**STAFF REPORT
KETCHUM PLANNING AND ZONING COMMISSION
SPECIAL MEETING OF FEBRUARY 23rd, 2021**

PROJECT: Warm Springs Ranch

FILE NUMBERS: P 21-001, P21-002, P21-003, and P21-010

APPLICATION TYPES: Development and Rezoning Agreement, Large Block Preliminary Plat, Block 1 Subdivision Preliminary Plat, and Floodplain Development/Waterways Design Review

C-3

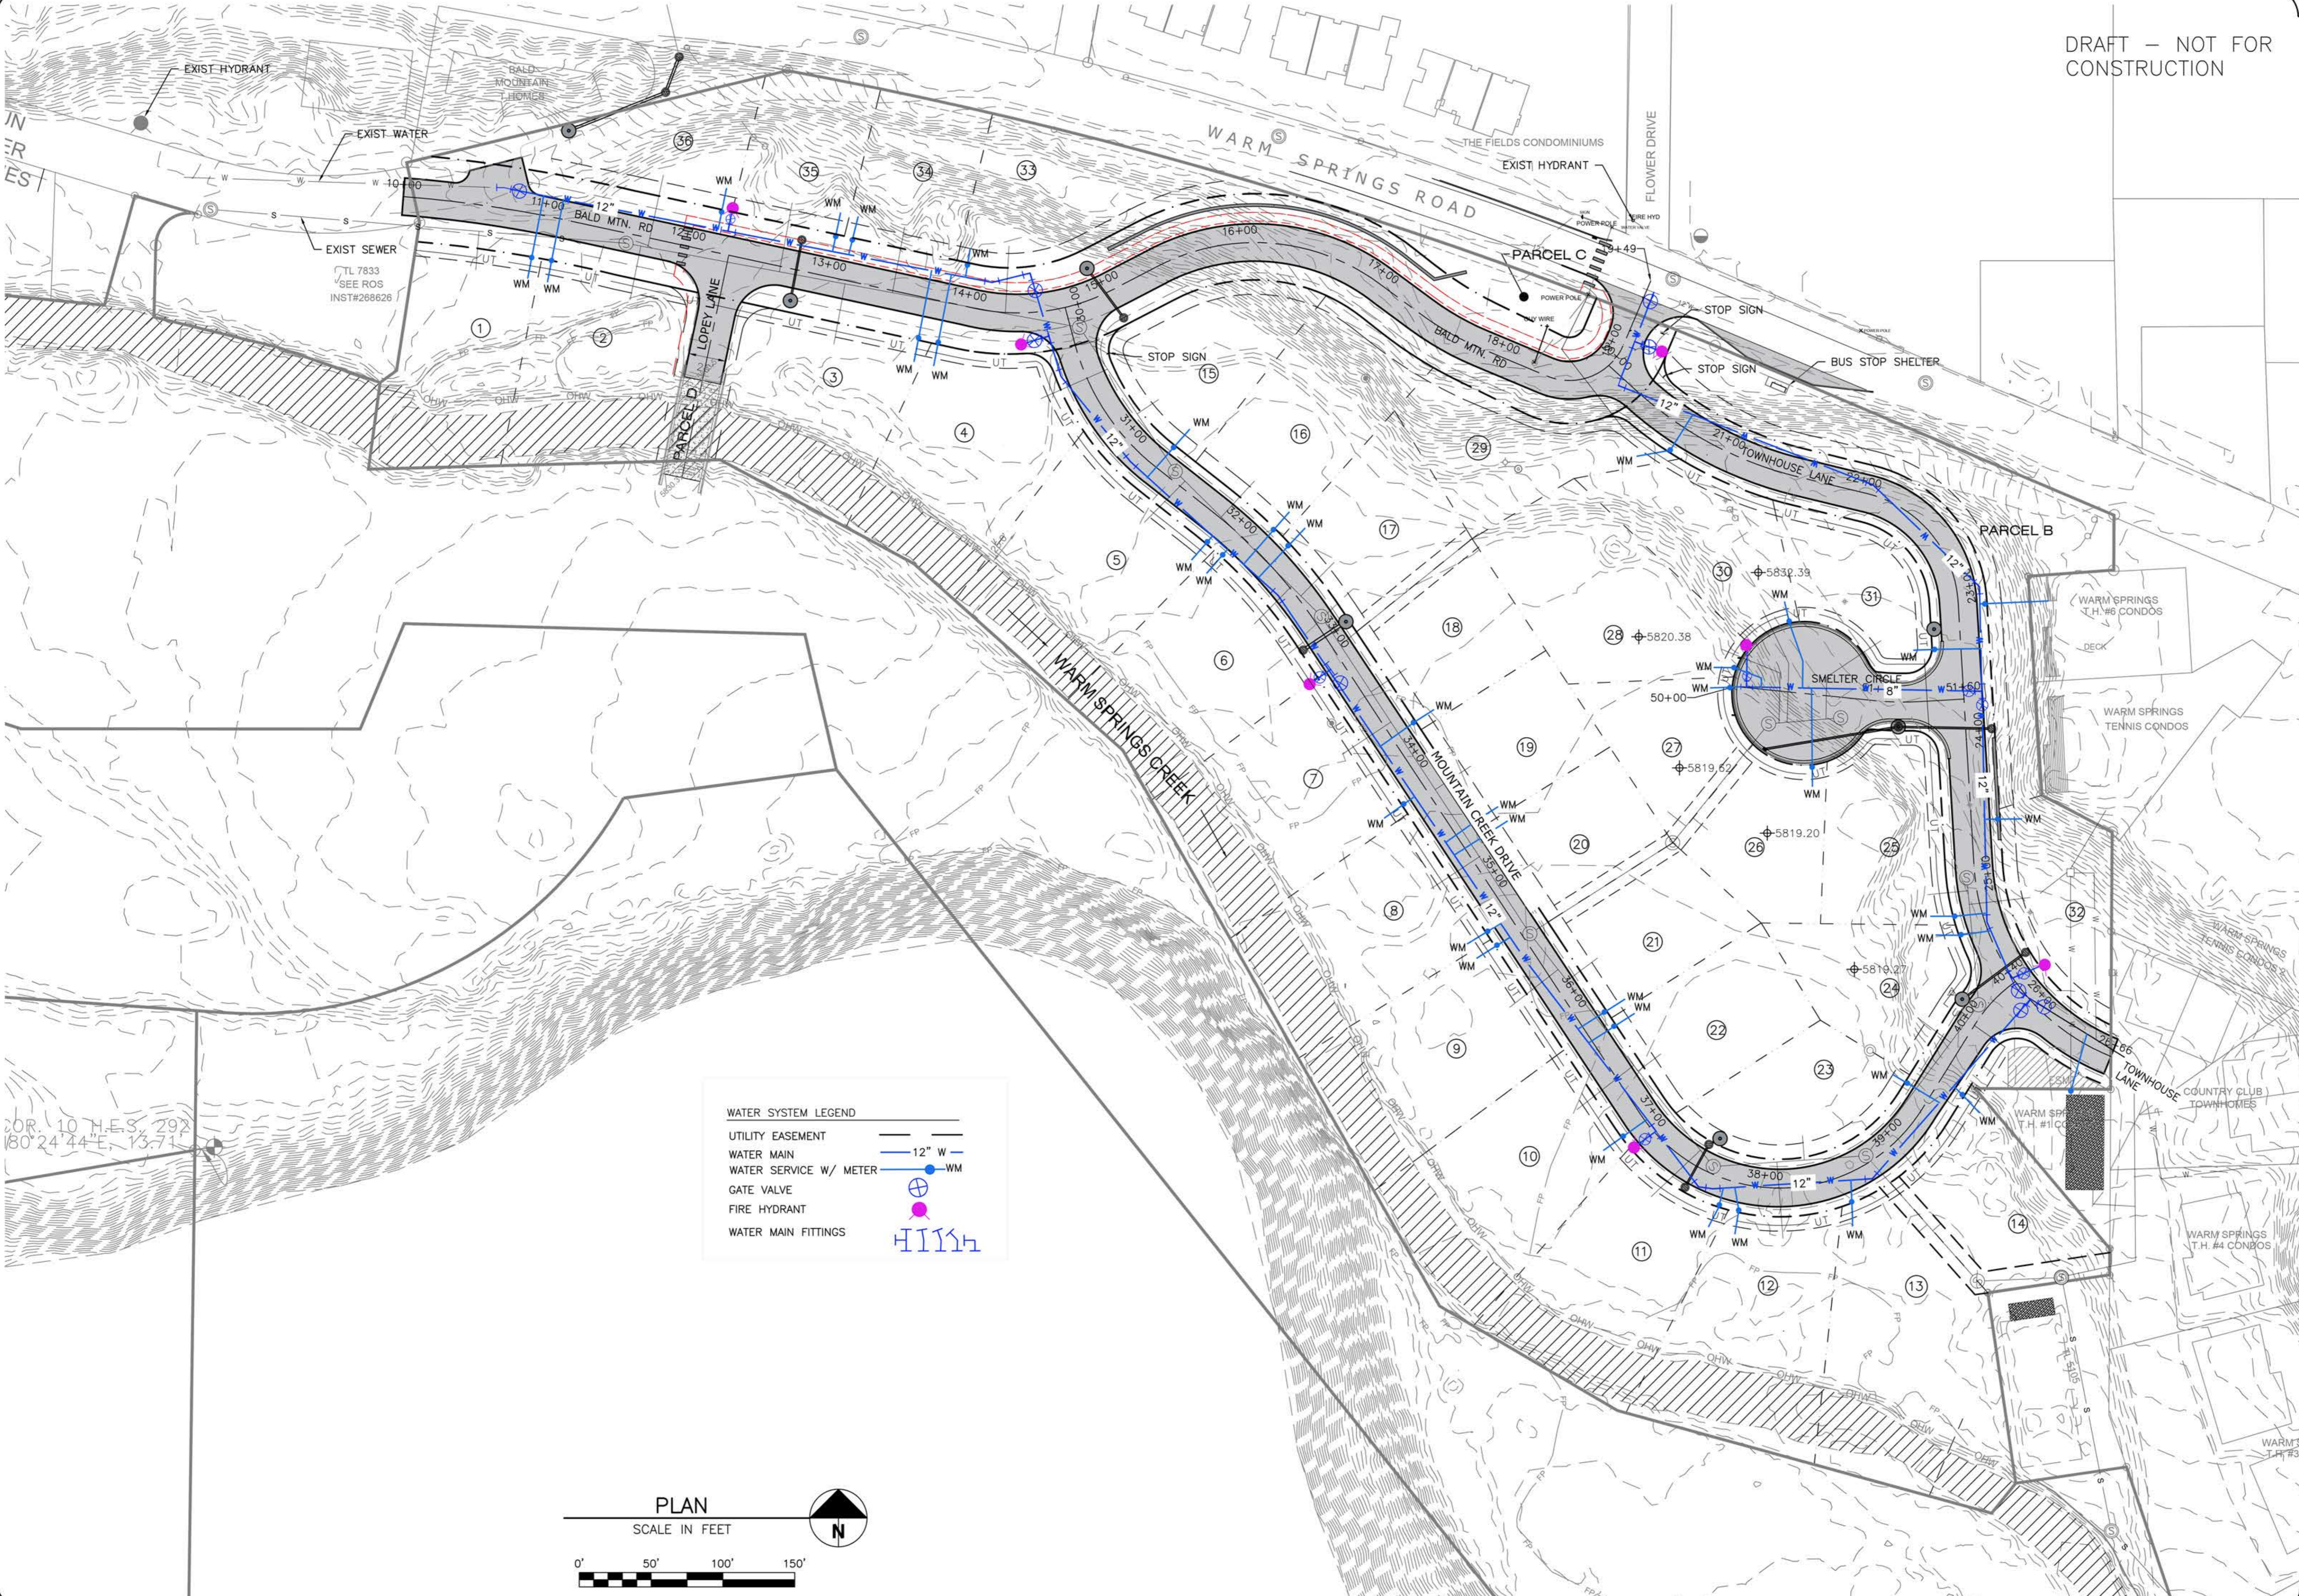
Staff Comments	<i>The new bus shelter is indicated on Parcel B (Sheet C-3). Mountain Rides has reviewed and approved the preliminary plans for the proposed bus stop location.</i>
<input checked="" type="checkbox"/>	<input type="checkbox"/>	<input type="checkbox"/>	16.04.040.R	R. Avalanche And Mountain Overlay: All improvements and plats (land, planned unit development, townhouse, condominium) created pursuant to this chapter shall comply with City of Ketchum Avalanche Zone District and Mountain Overlay Zoning District requirements as set forth in Title 17 of this Code.
			Staff Comments	<i>The Block 1 Subdivision Preliminary Plat will create 36 single-family residential lots and parcels A, B, C, D, and E. The proposed Development Agreement will rezone Block 1 from Tourist (T) to General Residential (GR-L) Low Density. Portions of Block 1 are also within the Floodplain Overlay and Avalanche Zone.</i>
